ADDENDUM NO. 3

ISSUING ENTITY: City of Apalachicola, Florida

SOLICITATION ID: RFP 2026-009

PROJECT TITLE: Construction Services Critical Asset Flood Mitigation Projects

SHEET
C5.2

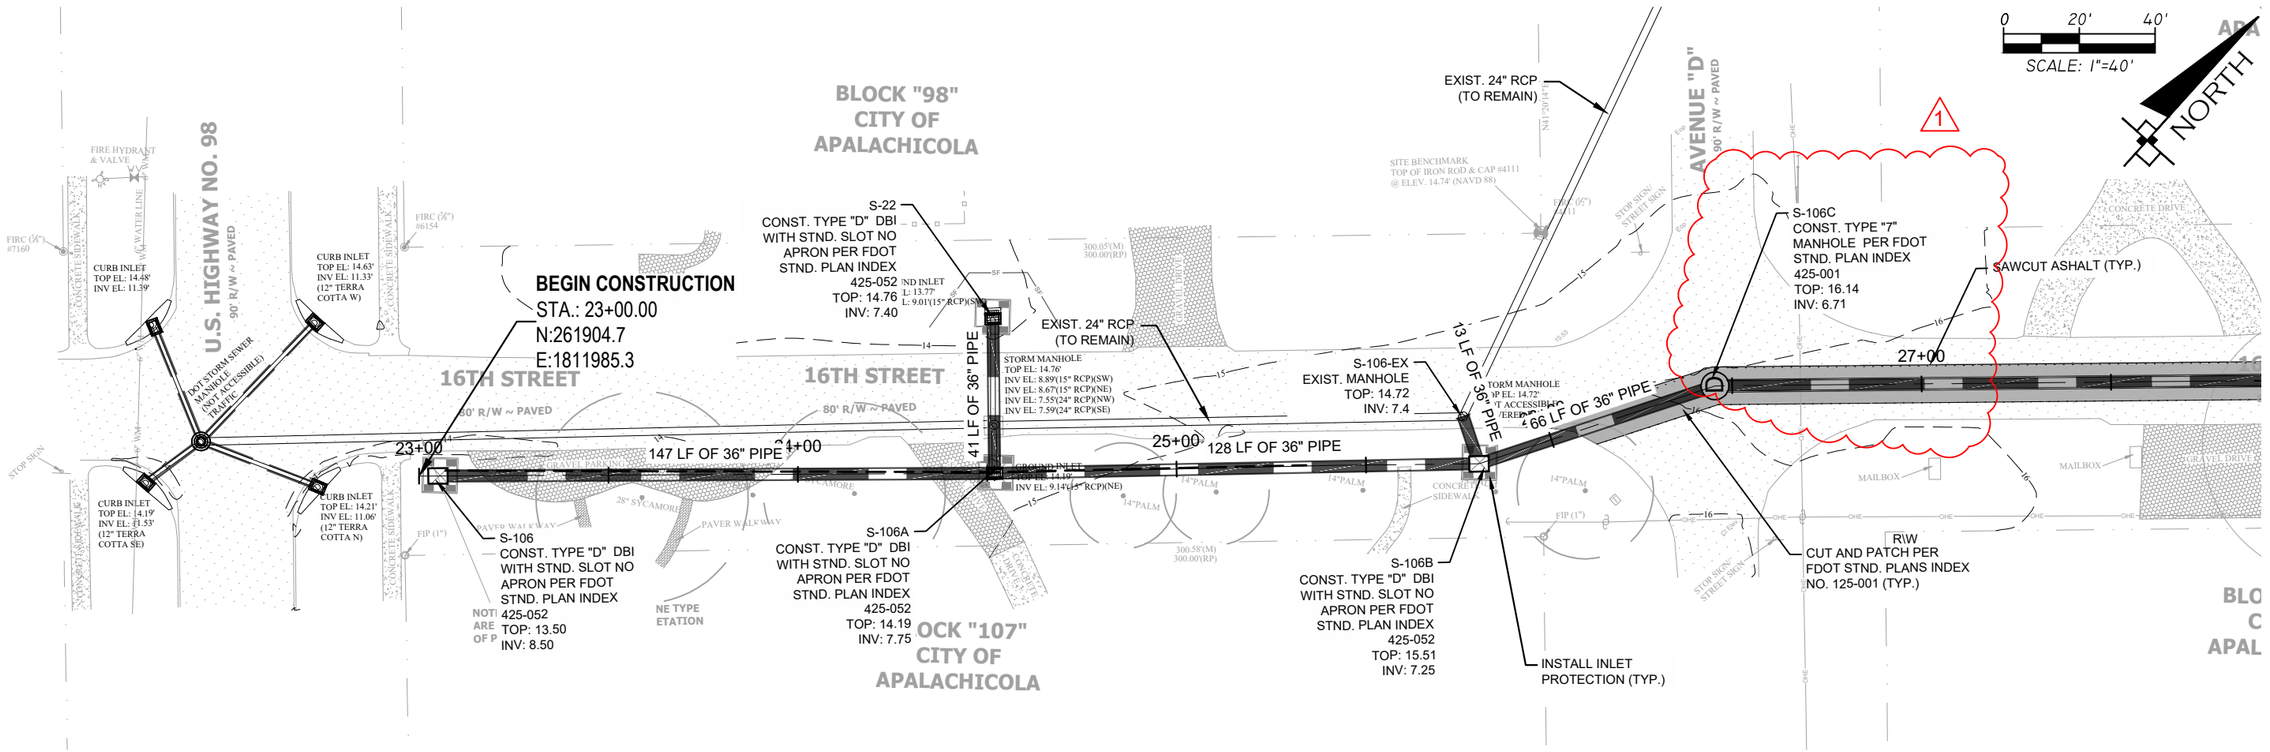
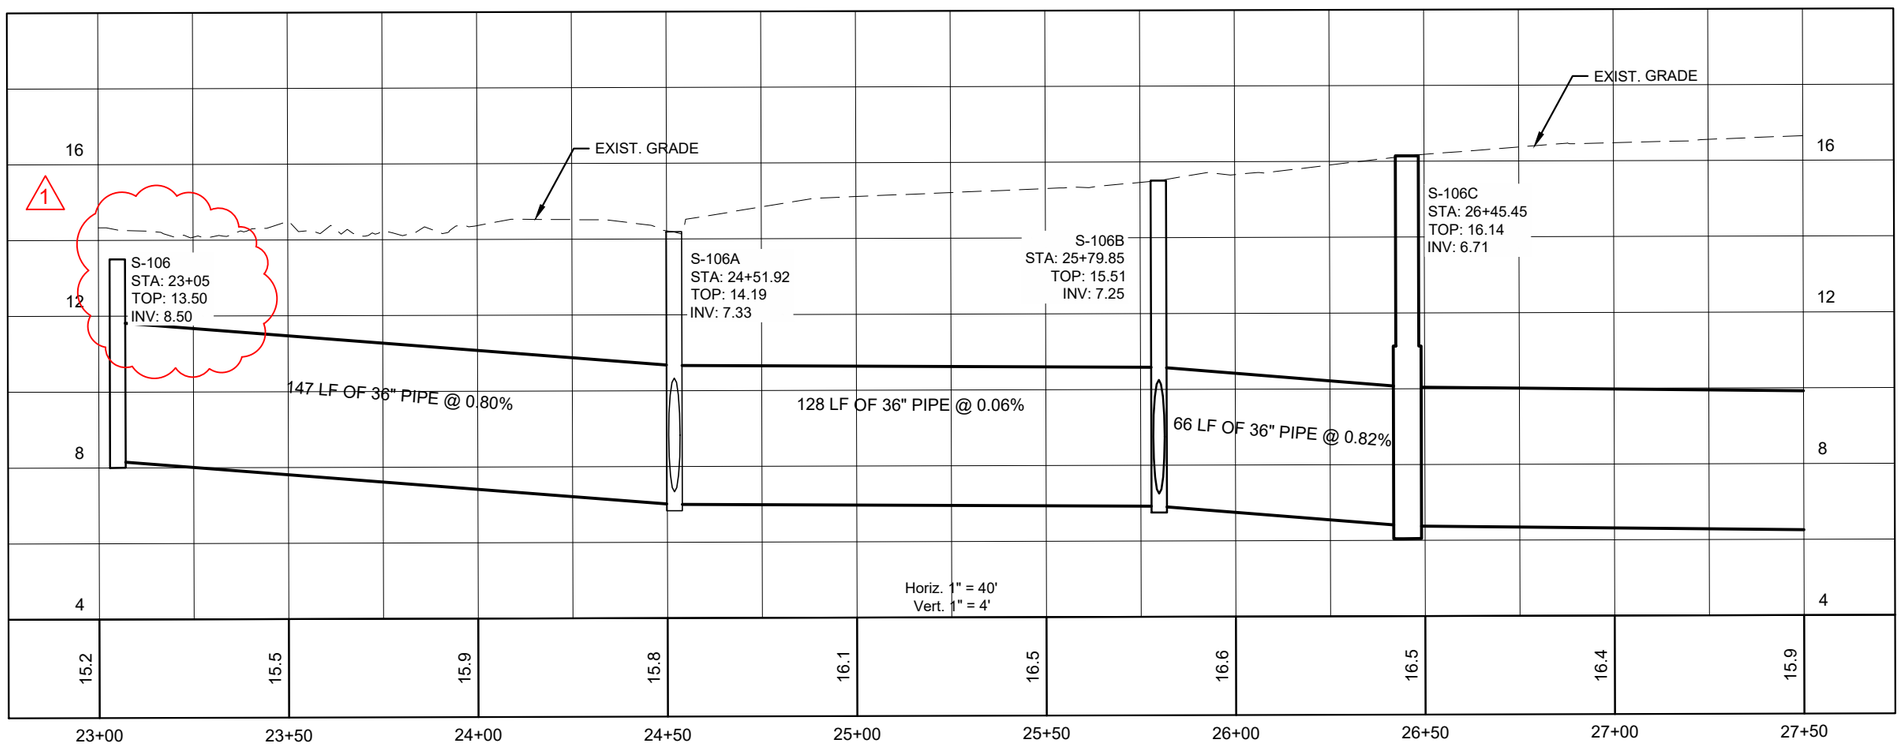
6. **Question:** Sheet 5.2 at the SE end shows the existing 15" RCP to be removed. Is the structure at the end to be removed as well? Pipe demo will require asphalt cut and patch @ Ave G.

Answer: The 15" pipe on Sheet C5.2 is to remain. See revisions.

SHEET
C7.0

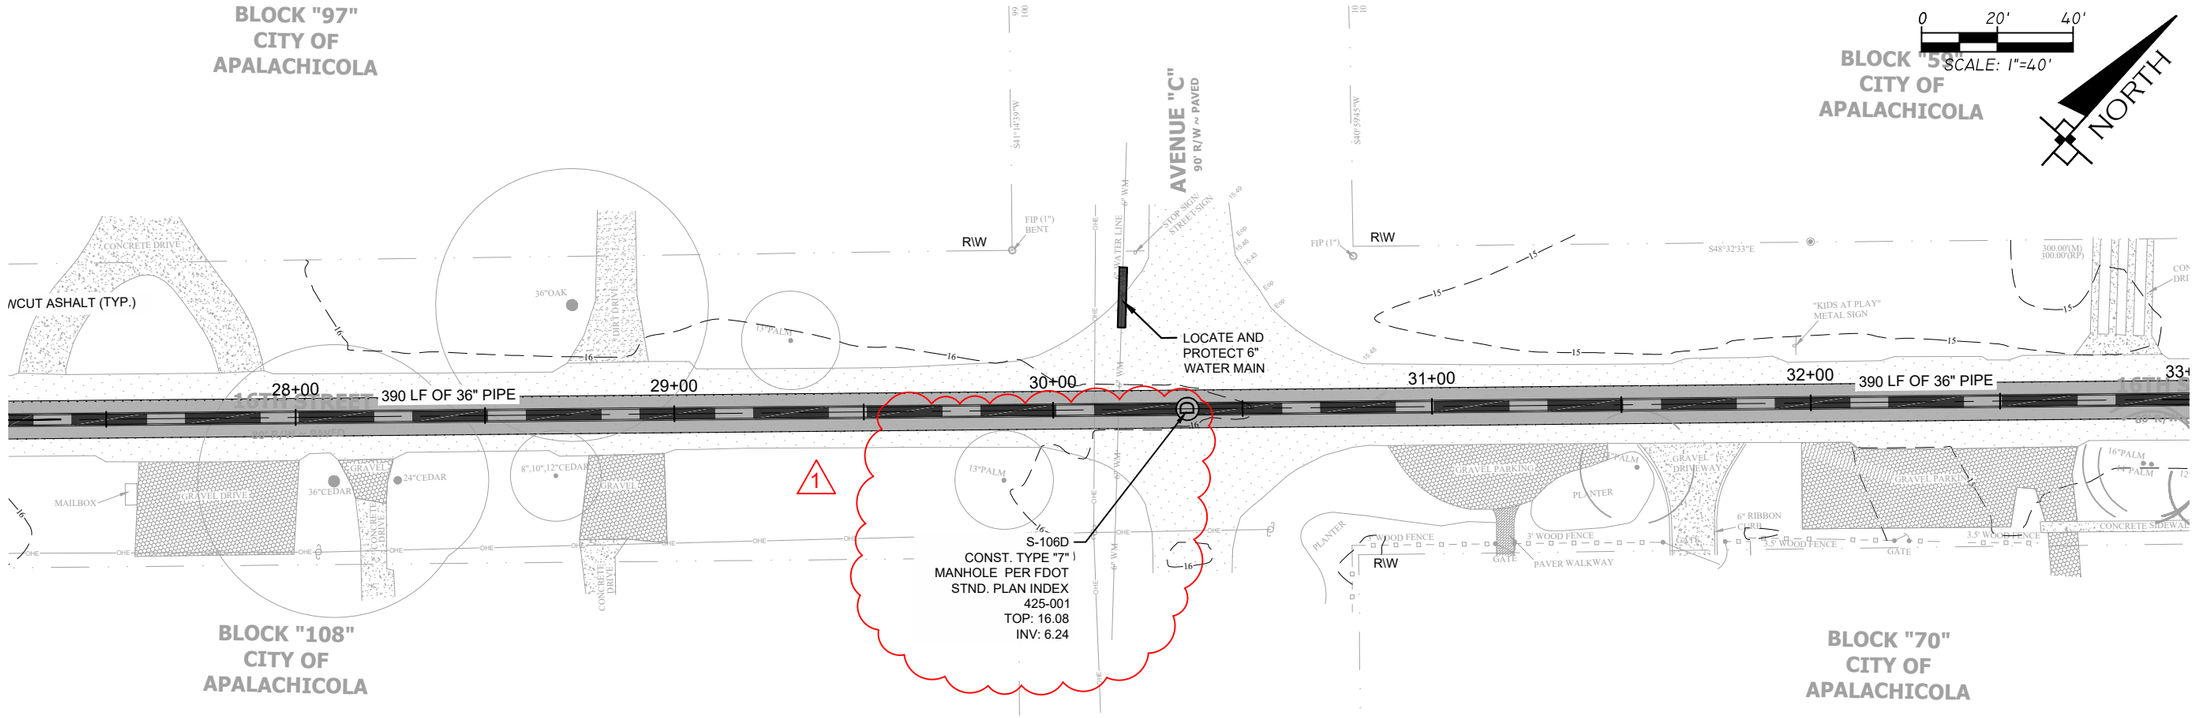
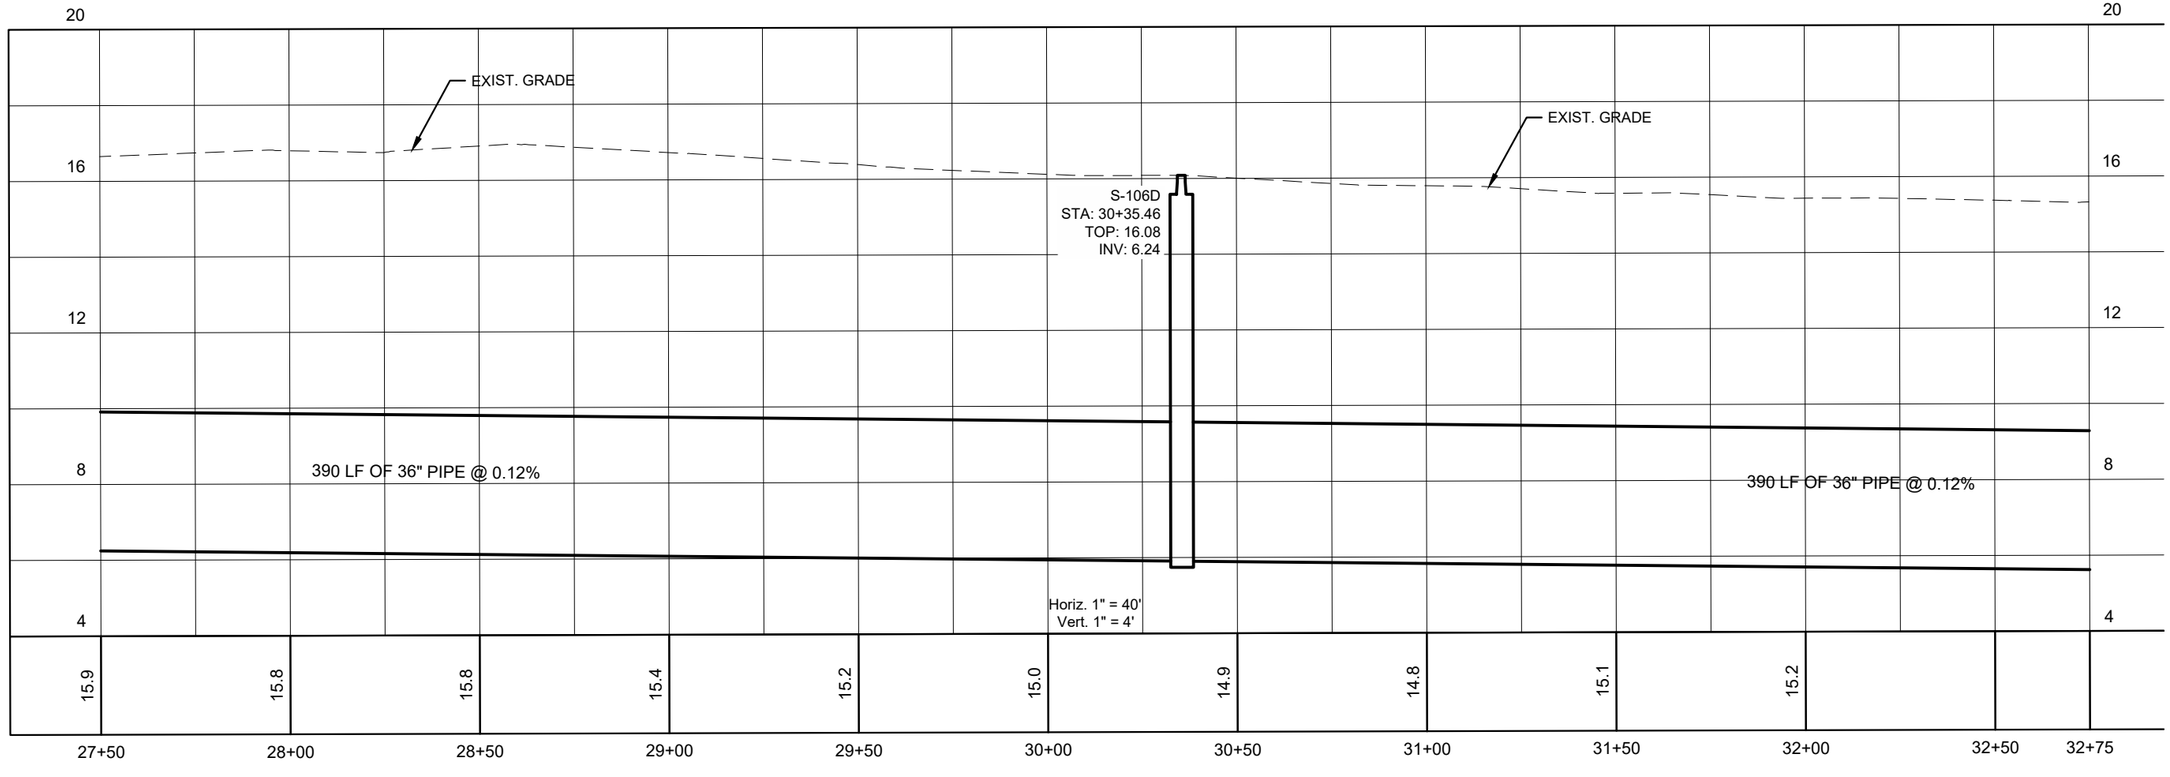
1. **Question:** Bid item: 0425-2-41- plan view for structures #'s are different than profile. Can these be changed to match?

3. **Question:** Bid item calls out for 329' of 36" rcp. Plans show 1247' please verify qty.

Answer: The discrepancies in structure identification on Sheets C7.0 through C7.2 are acknowledged. Revisions have been made so the structure #'s are the same in both plan and profile view.

Answer: The 36-inch pipe quantity for Location 106 has been revised from 329 LF to 1,247 LF to match Sheets C7.0 through C7.2. Plan callouts total 147 + 41 + 128 + 13 + 66 + 390 + 390 + 72 = 1,247 LF.

SHEET
C7.2

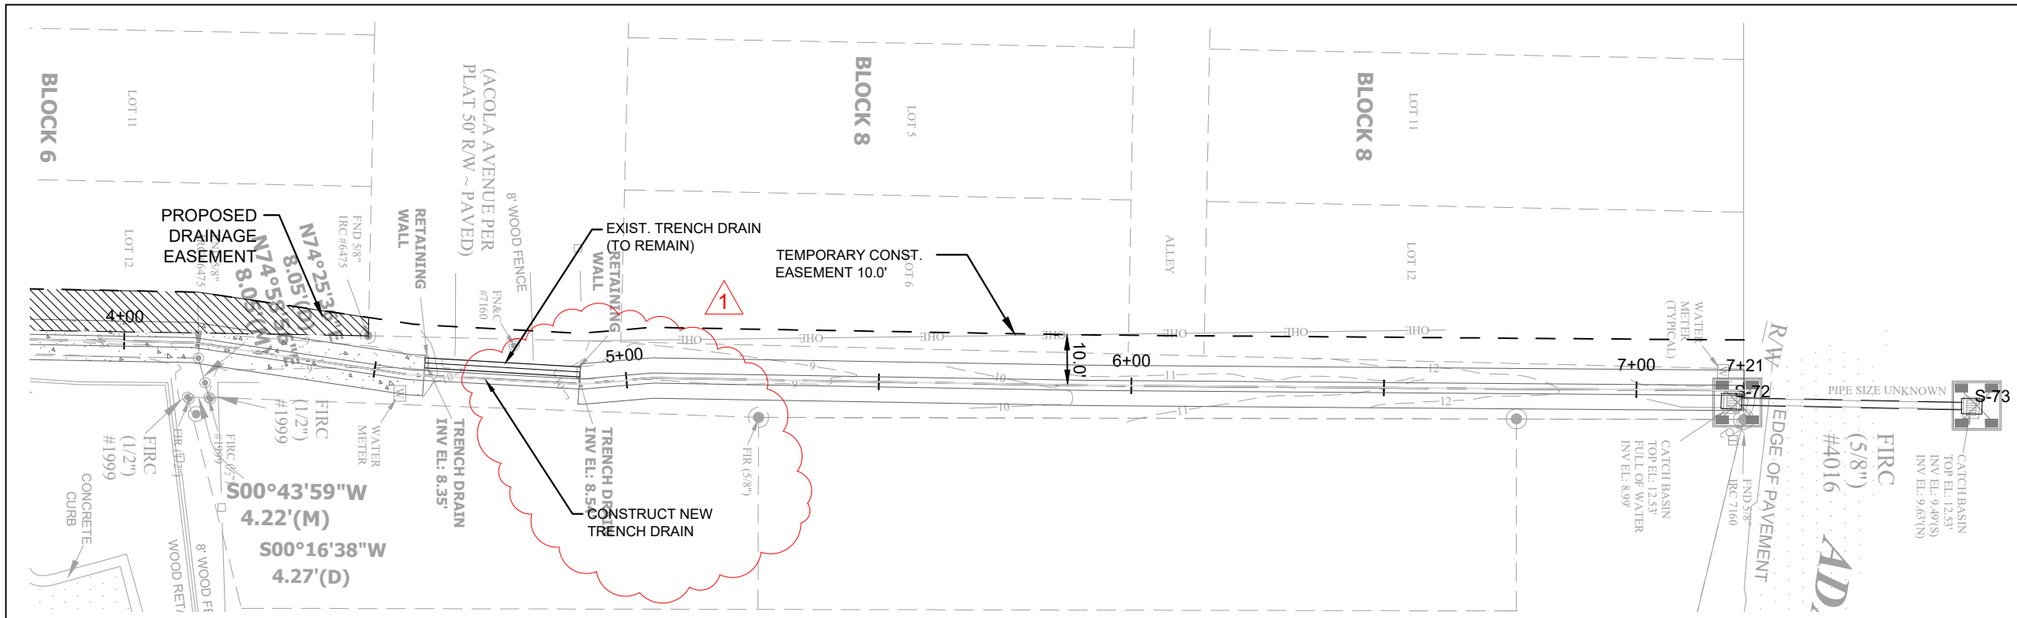
5. **Question:** Sheet 7.2 shows an existing 15" RCP and headwall noted "existing to remain" that appears to be located above the new 36" pipe. Can you clarify the intent for this project.

Answer: The existing 15-inch RCP and associated headwall on Sheet C7.2 are labeled to remain. The proposed new 36-inch pipe must be installed without damaging or obstructing the existing drainage system.

SHEET
C9.1

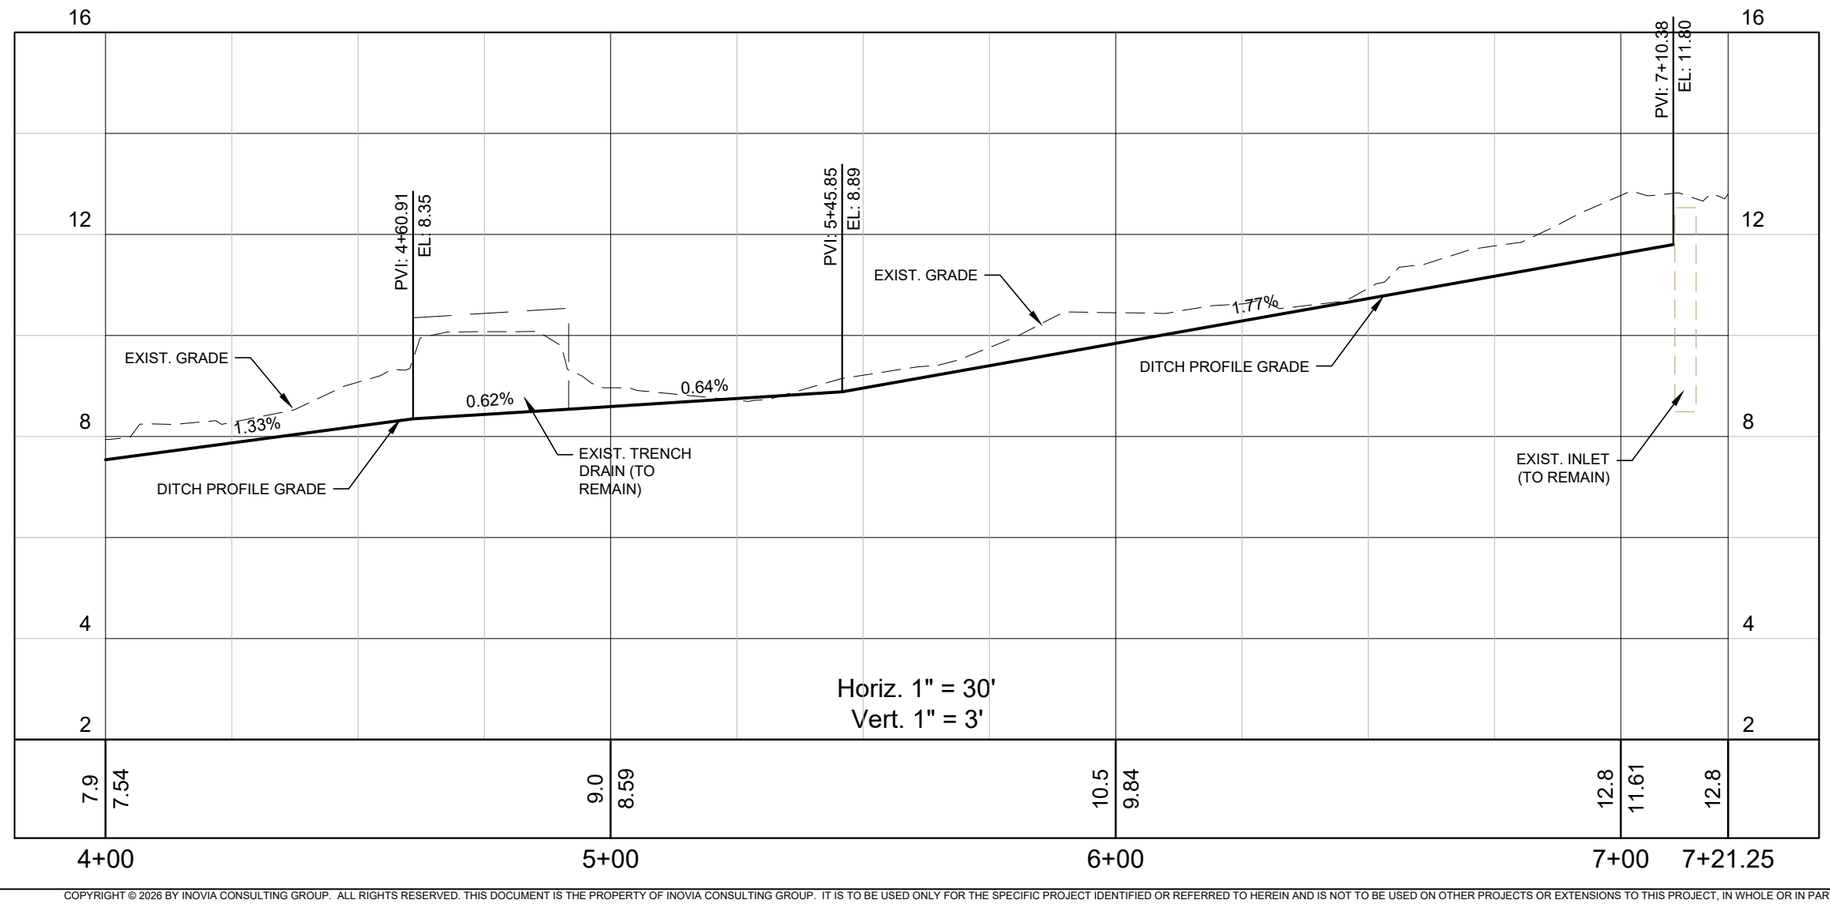
1. **Question:** Bid item 0436-1-1- bid item calls out for 30’ of trench drain. Plans say to keep existing trench drain. Are we replacing or keeping? Also is there a detail for the trench drain and size?

Answer: There is currently an existing 30’ trench drain. A secondary trench drain shall be constructed beside the existing trench drain. Clarifications have been made to sheet C9.1. Please note location 108 is not permitted for construction until easement is obtained.
